Introduction

This is a series of volumes which deal with specific TV receiver troubles and their cures. These trouble cures are the TV manufacturers' answers to some of the problems that may arise in their particular receivers.

Fig. 1 — Magnavox

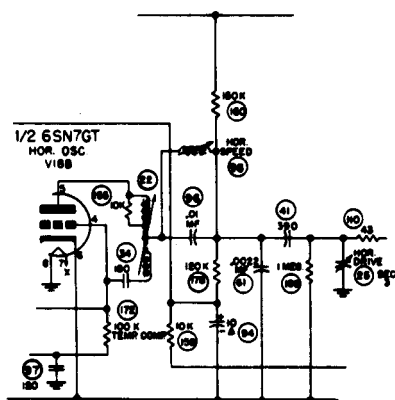
MAGNAVOX Chassis CT214
Improved horizontal stability
 (see Fig. 1).

An iron-slug speed coil (part No. 360346G1) as horizontal-oscillator frequency control is used in later production runs of the above chassis instead of the 120- μmf unit originally employed. Should it be desired to install this unit for improved stability of horizontal deflection, instructions outlined below should be followed:

1. Remove fixed capacitor *C33* (connected to pin 3 of sync clipper) and replace with mica capacitor 180 μmf , 10%, 500 volts (part No. 250159G85). Note: The capacitor which is removed may be used in step 3 below.

2. Remove horizontal speed capacitor. This will be the center capacitor of the three-gang trimmer *C25*.

6. Connect one side of coil to 2nd lug from the end of strip nearest horizontal-linearity coil *L13*. Remove resistor *R155* (10,000 ohms) and retain for use in step 8.

Fig. 2 — Majestic

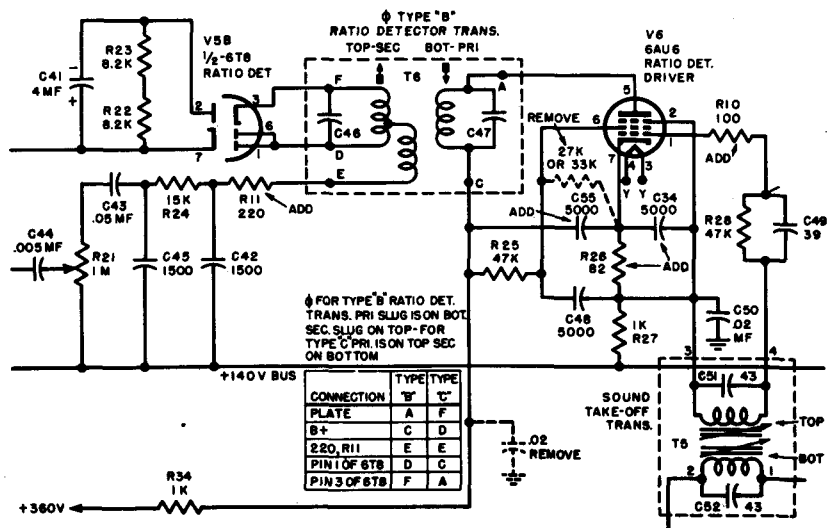
1. Remove the .02- μ f, 400-volt paper capacitor (6AU6 plate decoupling at junction of 1-k (*R34*) and 47-k (*R25*) resistors, located at a

2. Remove the 6AU6 screen bleeder resistor (located at 6AU6 pins 6 and 7). This resistor is 33 k on 94 series and 27 k on 97 and 98 series receivers.

7. Remove from 6AU6 pin 1 the leads of 47-k resistor (R28) and 39- $\mu\mu\text{f}$ capacitor (C49) and insert from that junction (R28 and C49) a 100-ohm, $\frac{1}{2}$ -watt resistor (R10) to 6AU6 pin 1.

8. Remove from a terminal on the ratio-detector transformer the leads of 15-k resistor (R24) and 1,500- $\mu\mu\text{f}$ capacitor (C42), and insert from that junction (R24) and (C42) a 220-ohm, $\frac{1}{2}$ -watt resistor (R11) to the same terminal on the ratio-detector transformer.

9. Remove jumpers between terminals 5 and 6 and between terminals 6 and 7 of the 6T8 (V5). Remove the leads from 6T8 pin 6 and reconnect to 6T8 pin 7. Insert jumper between 6T8 pins 5 and 7. Insert jumper with spaghetti between 6T8 pins 6 and 1.

Fig. 3 — Majestic

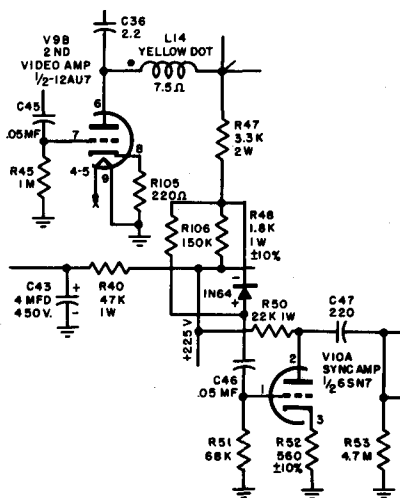
MAJESTIC Chassis 99 through 103, 105
Improved sync clipping and better horizontal hold
(see Fig. 3).

A crystal diode 1N64, is connected in series with the sync take-off lead to provide additional clipping action. The value of *R51* (grid resistor of sync amplifier) is changed from 1 meg to 68,000 ohms.

Also, in order to improve horizontal holding ability, *R106* (150-k resistor) is added across the 1N64 crystal.

A partial schematic diagram showing these changes as well as the change described under "Increasing sync amplitude" for these same chassis, is shown here.

Fig. 4 — Meck

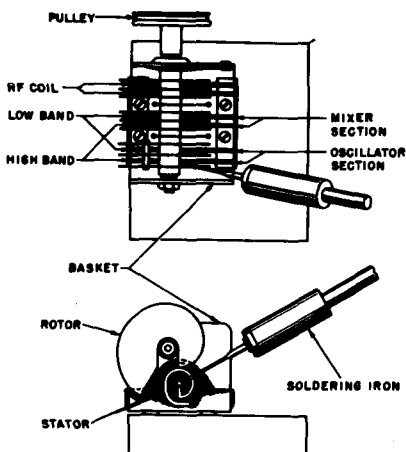
MECK Chassis with
TT-10006 tuner
Intermittent or low-sensitivity tuners (see Fig. 4).

The TT-10006 tuner depends upon a variable inductance for its correct operation. This variable inductance unit consists of the carriage, mounted on top of the tuner, the stator coil assembly, and the rotor plate assembly. The carriage is the U-shaped bracket which holds the copper rotor plate assembly and the rotor shaft. The stator coil assembly consists of six printed coils which are molded on linen bakelite strips. The center of each printed coil is terminated in a tinned eyelet which extends through the linen bakelite.

turned down and filed into the shape of a small screw driver blade. Run one-quarter inch of solder which has a very small diameter down the screwdriver blade to the eyelet. This operation should be done with the rotor blades turned out as far as possible, and should be necessary only for the oscillator and mixer coils as shown in the figure. It is unnecessary to remove the tuner from the television chassis to carry out this soldering operation; however, with the round-tube models, it may be necessary to bend the point of the iron at right angles in order to place the tip of the iron in the correct position.

Fig. 5 — Mercury

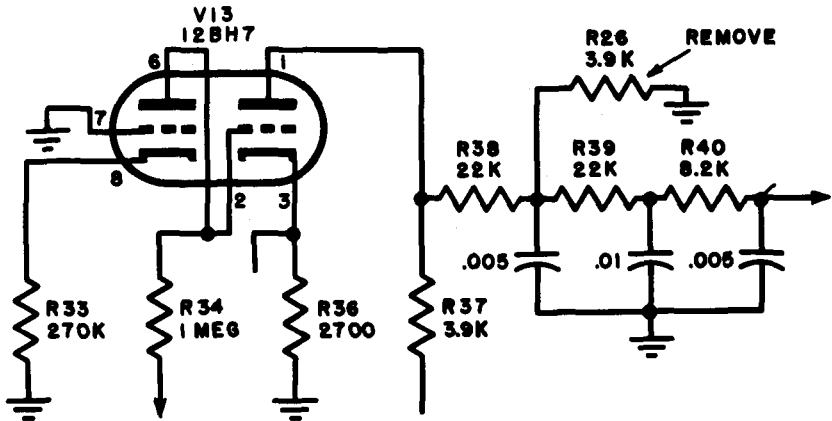
Occasionally it will be found that a chassis will not go through focus with the focus control at either extreme of rotation. This can be corrected by removing the back from the cabinet so that the focus coil can be reached. If the focus control is in its fully counterclockwise position when the best focus is obtained, it will be necessary to add a magnetic shunt to the focus coil. This can take the form of a small piece of steel approximately 1/2" x 1" from 1/32" to 1/16" thick. This should

be snapped onto the outer surface of the focus coil magnet with its long dimension running from front to rear. The best position to apply this is usually on the left side of the picture tube when facing the rear of the chassis. The focus coil magnetism will hold the shunt solidly in place. After applying the shunt, the ion-trap magnet should be readjusted and the set then checked for focus. If the correction was insufficient, a second shunt can be applied adjacent to the first one.

Fig. 7 — Montgomery Ward

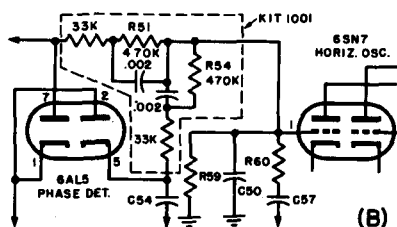
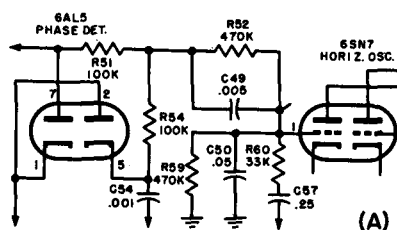
To correct this condition changes are made in the 6AL5 phase de-

tector circuit. Chassis already having these changes incorporated are stamped "YB" on the rear flange. Sets without these changes are stamped "YA." Part (A) of the figure shows the original (YA) 6AL5 circuit and part (B) shows the revised (YB) circuit. All parts necessary to make this change are supplied pre-connected in kit form. The component parts in this kit are listed below:

Fig. 8

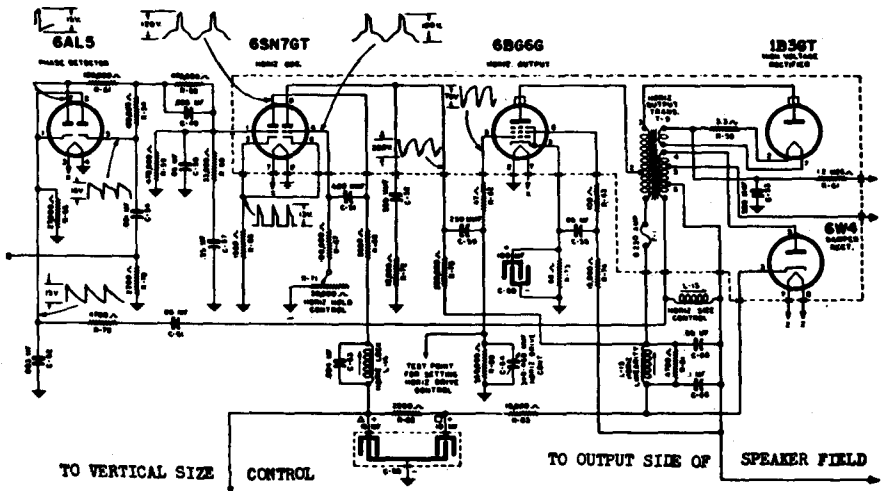
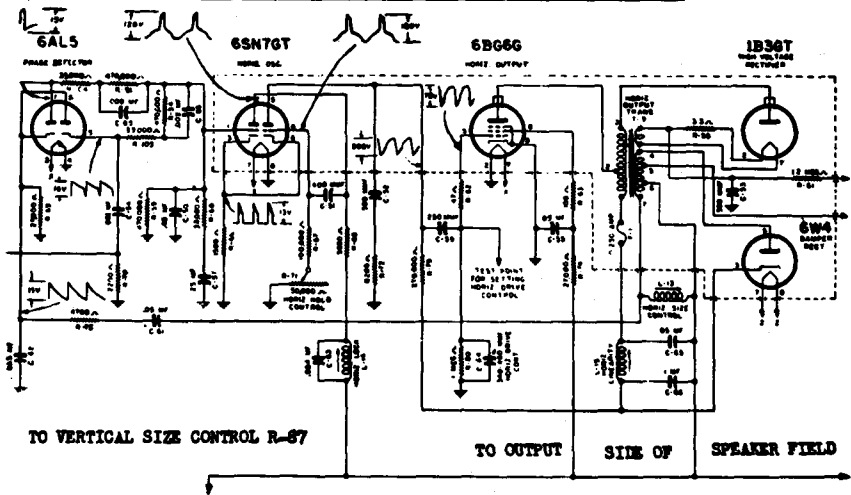
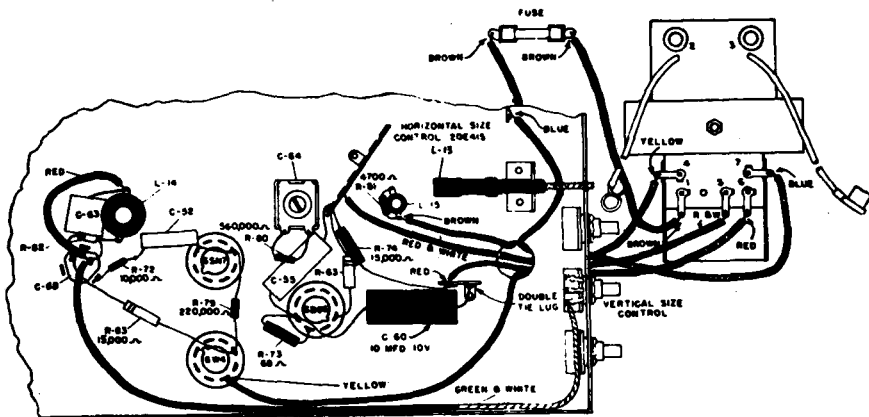
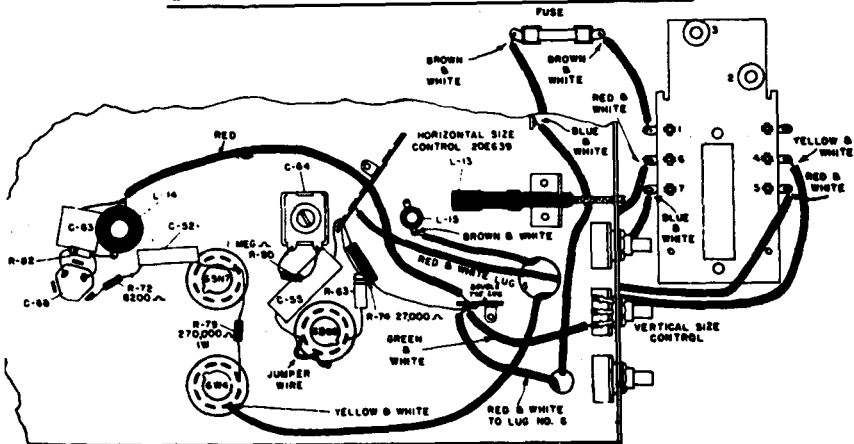
Horizontal-output and h-v transformers 22E57-2 or 22E57-3 replace the transformer part No. 22E57 used in receivers having "Series YA, YB, and YC" stamped on the back of the chassis.

Due to changes in construction of the flyback transformer it is necessary to revise the circuit slightly and change several components for proper operation of the set when replacing the 22E57 transformers (see circuit and wiring changes). To do this proceed as follows:

1. Replace the horizontal-output and h-v transformer with new transformer and connect as shown.

2. Change the 10,000-ohm, $\frac{1}{2}$ -watt peaking resistor *R72*, located in the 6SN7 horizontal-oscillator output circuit, with an 8,200-ohm, $\frac{1}{2}$ -watt resistor, part No. 27E822-2.

4. Change the 15,000-ohm, 2-watt resistor *R74* (some sets used two 7,500-ohm, 1-watt resistors in series) in the screen circuit of the 6BG6G horizontal-output tube to a 27,000-ohm, 2-watt resistor, part No. 27E273-5.

5. Change the 560,000-ohm, $\frac{1}{2}$ -watt resistor *R80* across the drive control in the grid circuit of the 6BG6G horizontal-output tube to a 1-meg, $\frac{1}{2}$ -watt resistor, part No. 27E105-2.

6. Disconnect the 100- μ f, 10-volt bypass capacitor *C60* and the 68-ohm, $\frac{1}{2}$ -watt resistor *R73* in the cathode circuit of the 6BG6G horizontal-output tube and remove.

8. Disconnect the 4,700-ohm resistor *R81* located across the horizontal-linearity coil *L15* and remove.

9. Disconnect the 15,000-ohm, 5-watt resistor *R83* (some sets used four 15,000-ohm, 1-watt resistors in series-parallel) and remove.

10. Clip out the lead between the horizontal-lock coil *L14* and electrolytic capacitor *C68* and reconnect the horizontal-lock coil with a longer length of wire to the B+ lug on the double-tie lug located adjacent to the vertical-size control.

12. Replace the horizontal-size control (part No. 20E415) coil *L13* with a new coil, part No. 20E639.

Fig. 9 — Montgomery Ward

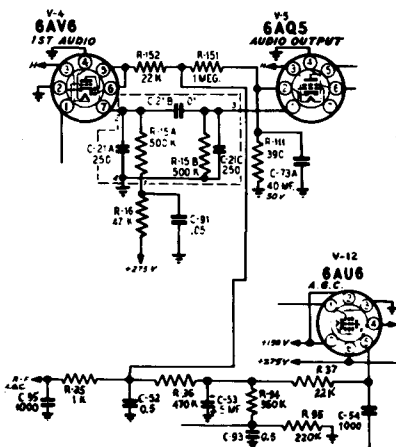
Near the end of production a change was made in the agc circuit to improve the signal-to-noise ratio for fringe-area operation. This

Remove the Following Components
in the Plate Voltage-Divider Circuit
of the Agc Tube

change is incorporated in the schematic diagram shown here.

Fig. 10 — Montgomery Ward

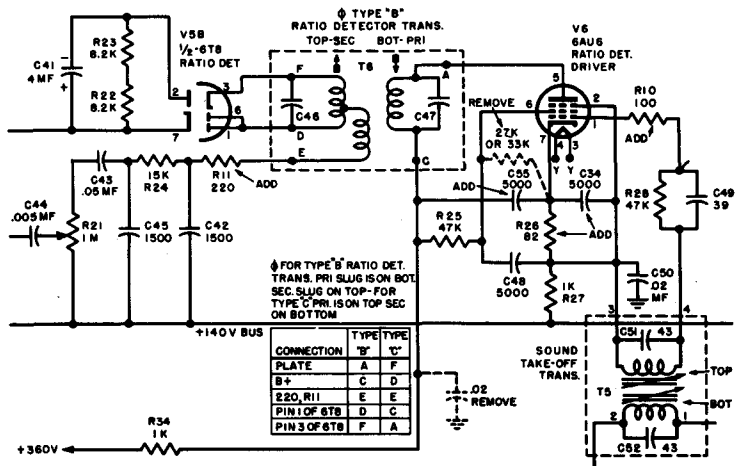
7. Remove from 6AU6 pin 1 the leads of 47-k resistor (*R28*) and 39- μ f capacitor (*C49*) and insert from that junction (*R28* and *C49*) a 100-ohm, $\frac{1}{2}$ -watt resistor (*R10*) to 6AU6 pin 1.

8. Remove from a terminal on the ratio-detector transformer the lead of 15-k resistor (*R24*) and 1,500- μ mf capacitor (*C42*) and insert from that junction (*R24* and *C42*) a 220-ohm, ½-watt resistor (*R11*) to the same terminal on the ratio-detector transformer.

Fig. 11 — Montgomery Ward

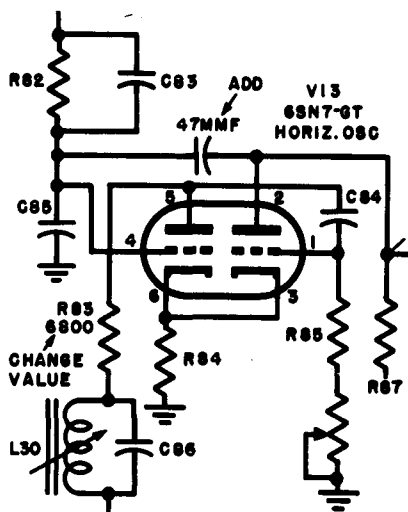
Models 84HA-3010 A, B, C
Improved horizontal sync
(see Fig. 11).

To improve the horizontal sync, proceed as follows:

Fig. 12 — Montgomery Ward

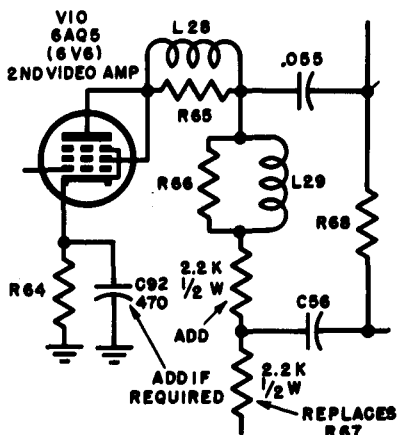
(see Fig. 12).

To obtain a greater white to black ratio proceed as follows:

Fig. 13 — Montgomery Ward

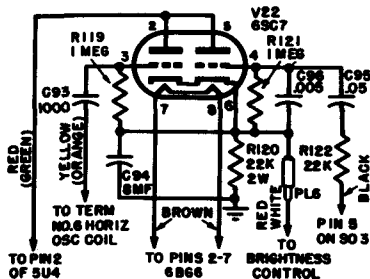
After these sets reached the field, a picture-tube protective circuit kit was made available for installation. The purpose of this circuit is to cut off the intense electron beam in the picture tube in event of failure in either the horizontal- or vertical-sweep circuits. This prevents burning a line into the face of the picture tube and rendering the tube useless.

Fig. 14 — Montgomery Ward

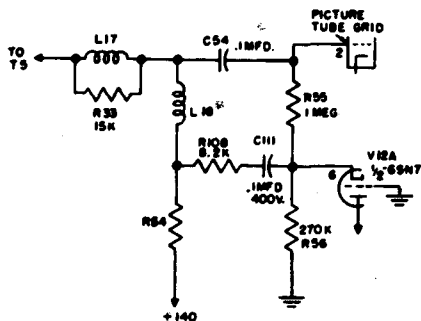
Picture twist at high brightness settings (see Fig. 14).

If picture twist occurs mainly upon advancing the brightness control, the d-c restorer circuit should be altered as follows:

Fig. 16 — Motorola

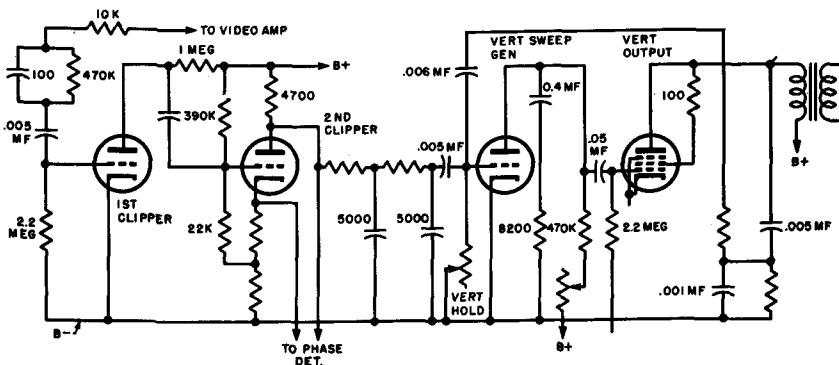
1. Replace the fuse temporarily with a milliammeter having a 150-ma scale.
2. Adjust the slug throughout its range. It will show a peak on the meter of 125—130 ma at both ends of its range.
3. Find the point in between where the meter dips to approximately 90

ma with good horizontal linearity. This is the proper setting of the core.

Fig. 17 — Motorola

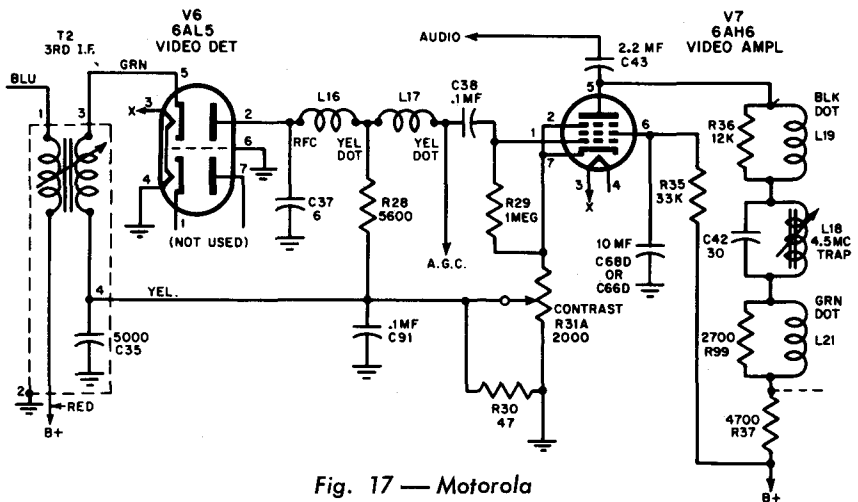
MOTOROLA Chassis TS-89, TS-95
Improved compensation
(see Fig. 17).

An improvement in picture quality is achieved with a change in compensating coils. *L17* (in video-detector circuit) is changed from a red-dot coil to a yellow-dot coil; *L19* (in plate circuit of video amplifier) is changed from a red-dot coil to a black-dot coil; and *L21* (in plate circuit of video amplifier) is changed from a green-black dot coil to a green-dot coil. With this change in compensation, the R-C network on the tapped contrast control, *R31A*, is eliminated. Later production runs already include this modification.

Fig. 21 — Motorola

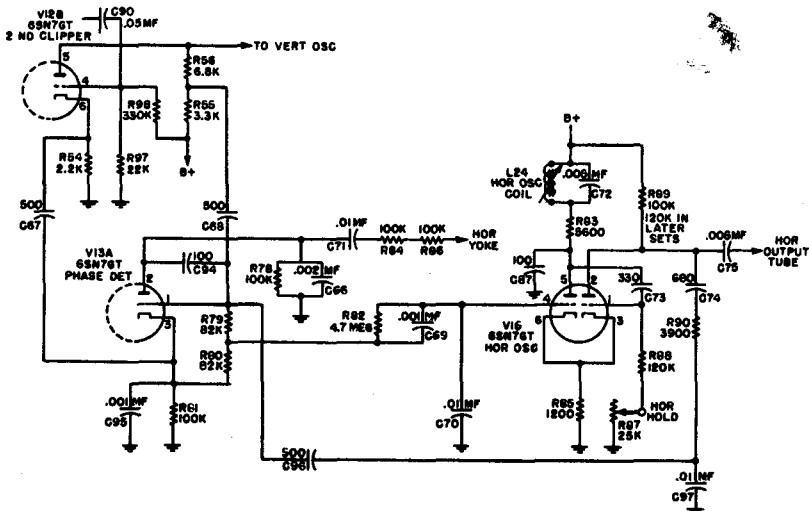
L17 (in video-detector circuit) changes from a blue-dot coil to a white-dot coil; L18 (in video-amplifier plate circuit) changes from a black-dot coil to a red-red dot coil; R30, the video amplifier plate load, changes from 5,600 ohms to 3,900 ohms; C93 and R103 in the cathode-circuit compensating network of the

video amplifier are deleted; and *L18* and *L19*, the 4.5-mc trap are interchanged, with this revision.

Fig. 22 — Motorola

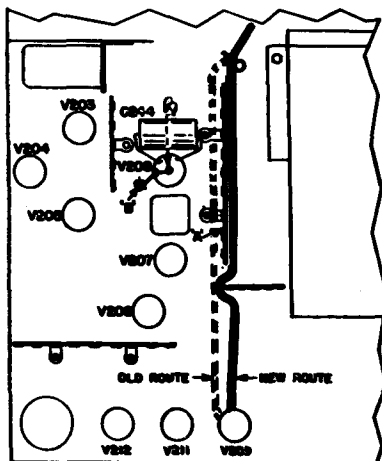
1. Replace the shielded contrast lead with an unshielded lead.
2. The shielded volume - control lead is originally routed between the terminal strip (A) and the audio i-f strip. Reroute this lead to the other side of the terminal strip to minimize the 4.5-mc pickup in the lead.
3. The ground lead from the center pin of the ratio-detector socket (V208, 6AL5) is originally dressed

over the 10- μ f electrolytic (C244) to a chassis ground kick-out. Move the lead from this kick-out to the kick-out near the tube socket on the video i-f side (B).

Fig. 26 — Muntz

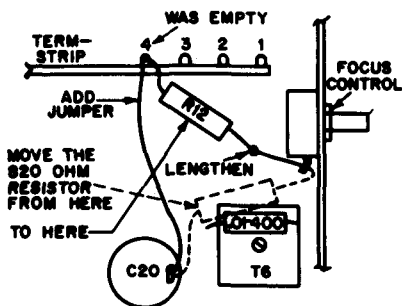
MUNTZ Chassis 17A series
Improved horizontal stability
(see Fig. 26).

A change in parts placement to improve horizontal stability was made in later production runs.

Fig. 29 — Muntz

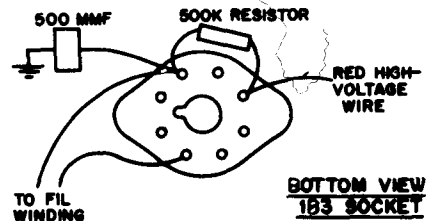
MUNTZ Chassis M169
Frying sound at low picture-control settings (see Fig. 29).

Fig. 32 — National

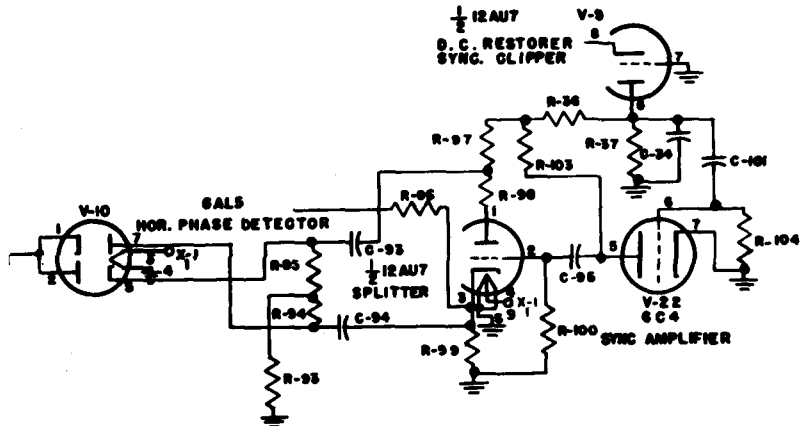
The affected portion of the schematic diagram is shown in the figure. Note the phase reversal at the horizontal phase detector tube *V10*.

Fig. 34—Pacific Mercury

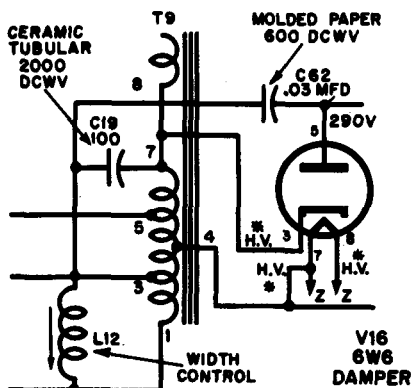
PACIFIC MERCURY All models
Horizontal-sync instability
 (see Fig. 34).

Fig. 35 — Packard Bell

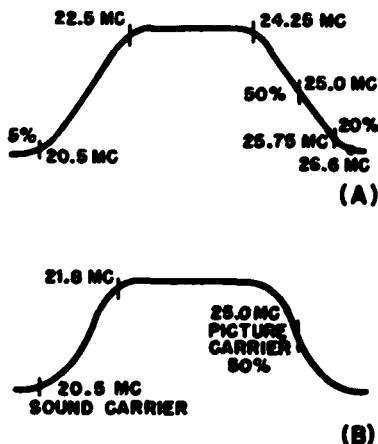
Alignment in fringe areas
 (see Fig. 35).

Fig. 36 — Packard Bell

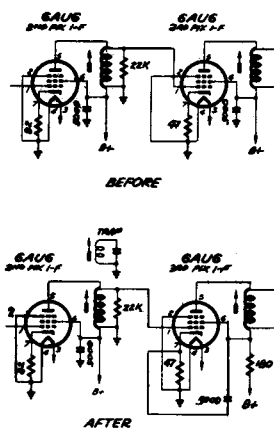
**Improved sensitivity in
fringe areas (see Fig. 36).**

Fig. 37 — Packard Bell

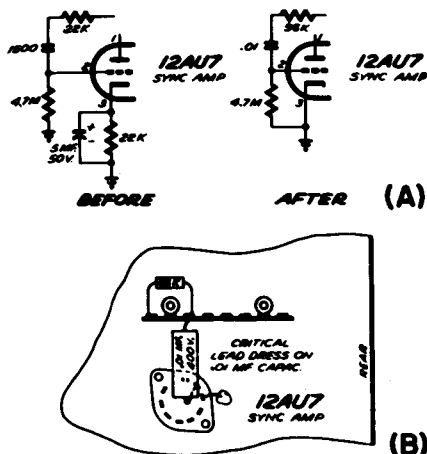
Most of the instability encountered in weak-signal areas is caused by noise pulses of long duration. The changes to the sync amplifier as shown in part (A) of the figure are to be used in fringe areas only. The lead dress of the .01- μ f coupling capacitor is critical. See part (B) of the figure for proper lead dress.

Fig. 42 — Philco

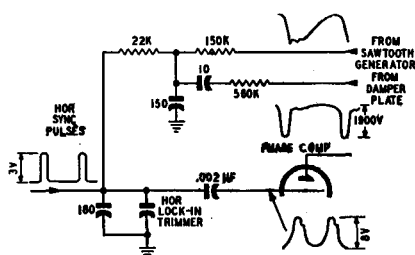
PHILCO Models 50-1403,
50-1630
Horizontal foldover
(see Fig. 42).

Fig. 46 — Philco

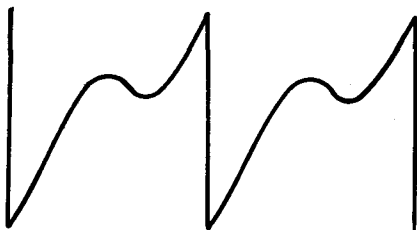
PHILCO Model 50-T1400
Horizontal-oscillator squeal
(see Fig. 46).

Fig. 47 — Philco

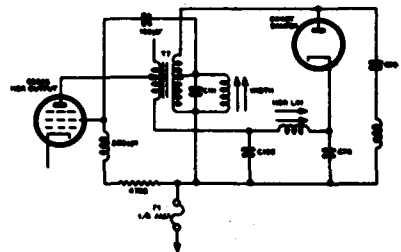
Reducing a-c current through fuse (see Fig. 47).

Fig. 48 — Philco

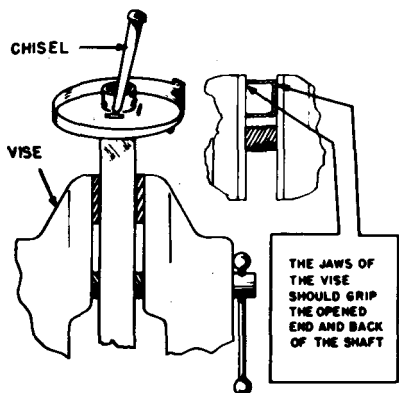
PHILCO Model 51-PT1200
Replacement of fine-tuning cam (see Fig. 48).

Fig. 53 — Philco

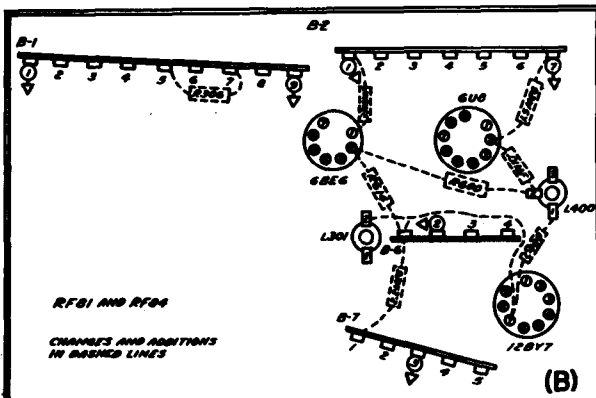
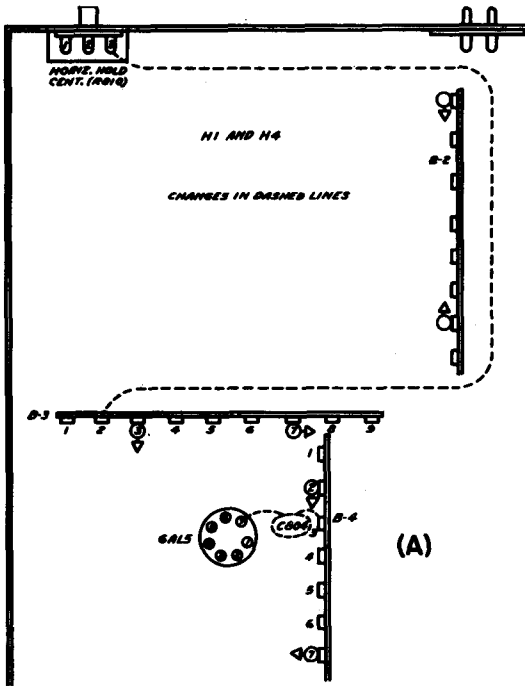
2. Remove lead between lug 2 of terminal panel *B3* and lug 3 of horizontal-centering hold control (*R810*). Refer to part (A) of the figure.
